Our Ref: R/2015/37/W  
File No: 2019/446885

**SSD 7317 – MOD 17 – Building 2 – Locomotive Street Retail Reconfiguration**

Figure 1: Area to be opened for additional amenity to rear seating area

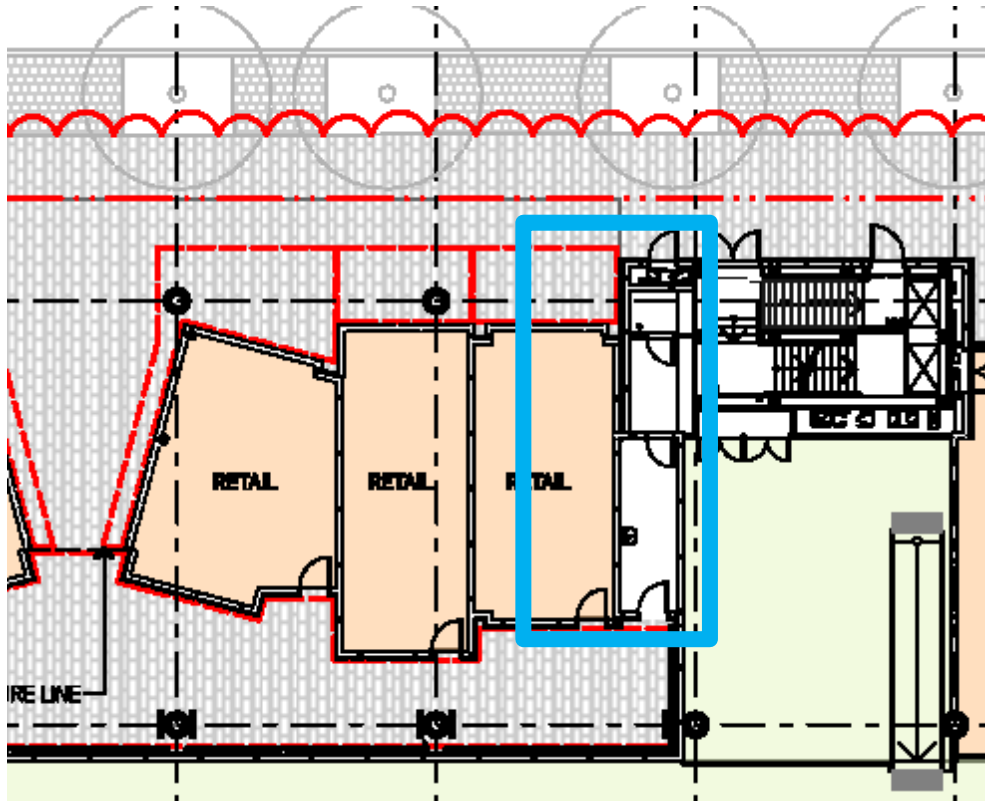
As noted during this meeting, the layout of the retail tenancies should be redesigned to allow for an additional opening next to the amenities of the north-east of the site for the rear external seating area (in blue outline below). This may result in the loss of some retail GFA but would provide for additional amenity for patrons.
